ADDENDUM NO. 2

Install Access Points for Wi-Fi
St Louis Veterans Home
Bellevuefontaine Neighbors, MO
PROJECT NO. U2411-01

SHEET TITLE:
**ELECTRICAL A-WING
DATA PLAN**

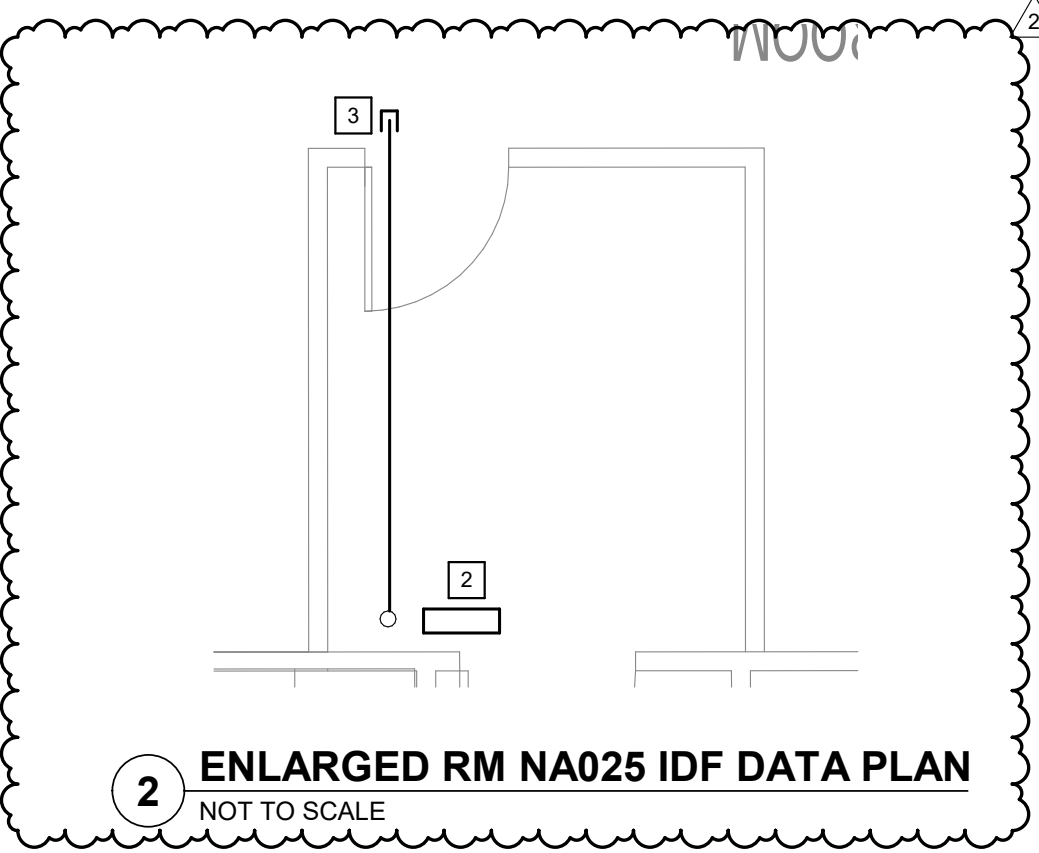
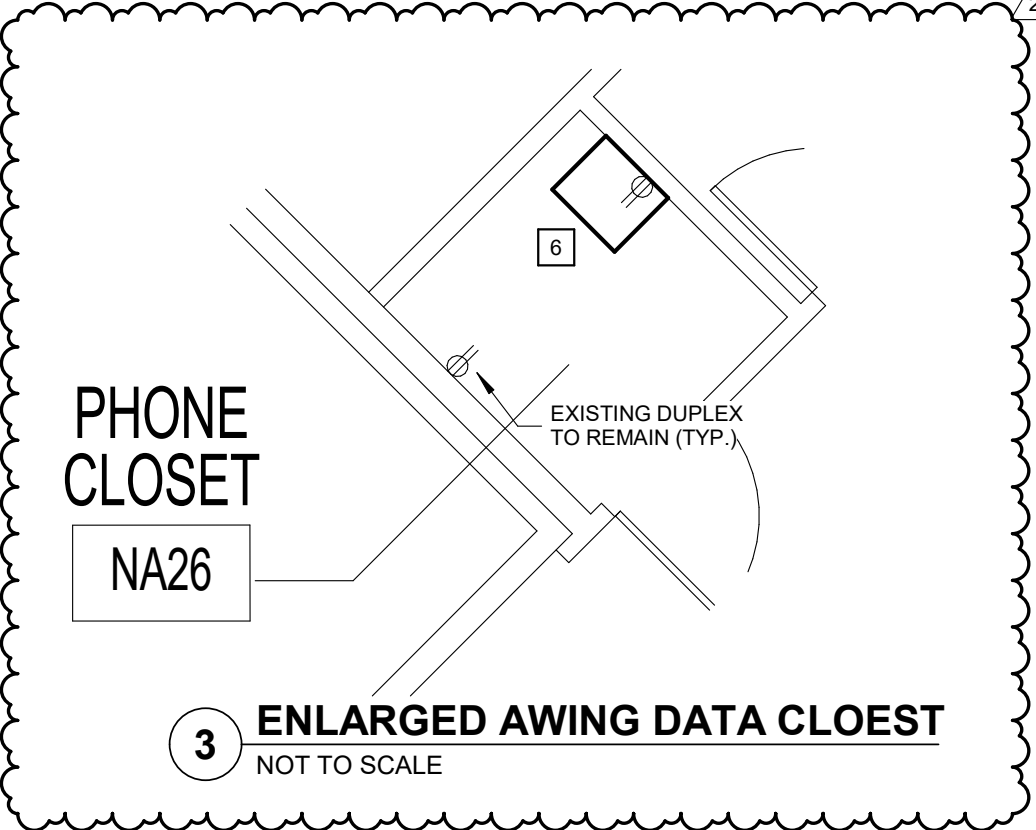
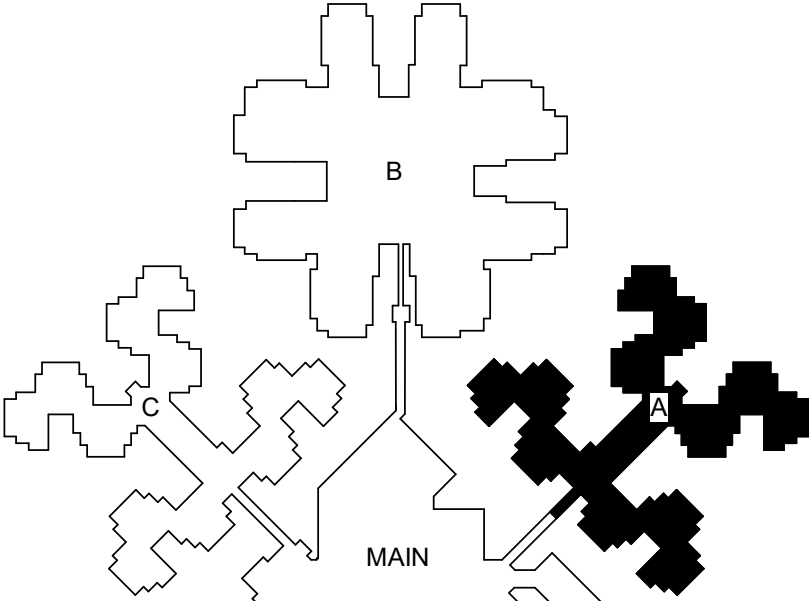
1. Sheet E1.0 – Full Sheet Re-issued
 - a. ADD Note reading: WING A & WING C BOTH HAVE ON-GOING RENOVATION WORK THAT IS NOT YET COMPLETED. ROOM NUMBERS ON THIS PLAN DO NOT MATCH THE FINAL ROOM NUMBERS. LABEL IDENTIFICATION/TAGGING WILL BE DISCUSSED AND COORDINATED WITH THE CONTRACTOR AT THE EARLY STAGES OF CONSTRUCTION.

- b. ADD to the end of General Note #4:
AT IT RACK, PROVIDE 4' SERVICE LOOP AND 4' PATCH CABLE FOR SWITCH.
 - c. MODIFY Keyed Note #2 to read:
"PROVIDE ONE (1) 48 PORT RACK MOUNT PATCH PANEL" in lieu of
"PROVIDE TWO (2) 48 PORT RACK MOUNT PATCH PANELS"

- d. RELOCATE Keyed Note #5 and MODIFY to read:
ROUTE DATA CABLING TO NEAREST IDF CLOSET IN THIS WING.
ANTICIPATED DIVIDER LINE BETWEEN THE TWO IDF CLOSETS IN THIS WING.

- e. ADD Keyed Note #6 to read:
PROVIDE NEW TRIPP LITE SMARTRACK 12U WALL MOUNT RACK (CAT#SRW12US33) WITH HINGED BACK, SWINGING DOORS AND REMOVEABLE SIDES; COORDINATE MOUNTING HEIGHT WITH LOCAL FACILITIES TEAM. MOUNT ON EXISTING FIRE RETARDANT PLYWOOD BACKERBOARD. IN THE CABINET, ADJUST THE FRONT RAILS TO BE 6" FROM THE DOOR. INSTALL RACK AND DOOR TO BOTH SWING AS DIRECTED BY LOCAL FACILITIES TEAM. PROVIDE ONE (1) 48 PORT RACK MOUNT PATCH PANEL IN THE NEW RACK. PROVIDE CAT 6 CABLING TO APPLICABLE ACCESS POINT IN THE A-WING FROM THESE NEW PATCH PANELS. AT EVERY ACCESS POINT, PROVIDE 10'

SERVICE LOOP AND TERMINATE AT A SURFACE MOUNT BOX ABOVE CEILING. CONNECT A CAT 6 PATCH CABLE FROM THE SURFACE MOUNT PATCH PANEL TO THE ACCESS POINT. LABEL ALL CAT6 CABLING AT BOTH ENDS WITH THE AP NAME. PROVIDE A 6' CAT 6 PATCH CABLE AT THE NEW PATCH PANEL, BUT DO NOT CONNECT CAT 6 PATCH CABLES TO THE SWITCHES. PROVIDE RACK MOUNTED, 1RU 12 PORT FIBER PATCH PANEL IN THE NEW RACK. PROVIDE 12 STRANDS OF ARMOR JACKETED, PLENUM RATED, MULTIMODE FIBER TO FIBER PATCH PANEL IN THE MAIN DATA ROOM 141. TERMINATE WITH LC CONNECTORS. IN MAIN DATA RACK, TERMINATE AT FIBER PATCH PANEL OUTLINED ON SHEET E1.3. AT NEW RACK, PROVIDE FIBER PATCH CABLE LONG ENOUGH TO REACH NEW NETWORK SWITCH FURNISHED BY OWNER'S IT DEPARTMENT. DO NOT CONNECT TO SWITCH, OWNER TO MAKE ALL FINAL CONNECTIONS.

- f. Floor plan changes as shown on plan include but not limited to:
 - i. Location of IDF Closet was adjusted.
 - ii. Added a second IDF and additional scope.
- 2. Sheet E1.2 – Full Sheet re-issued
 - a. ADD Note reading:
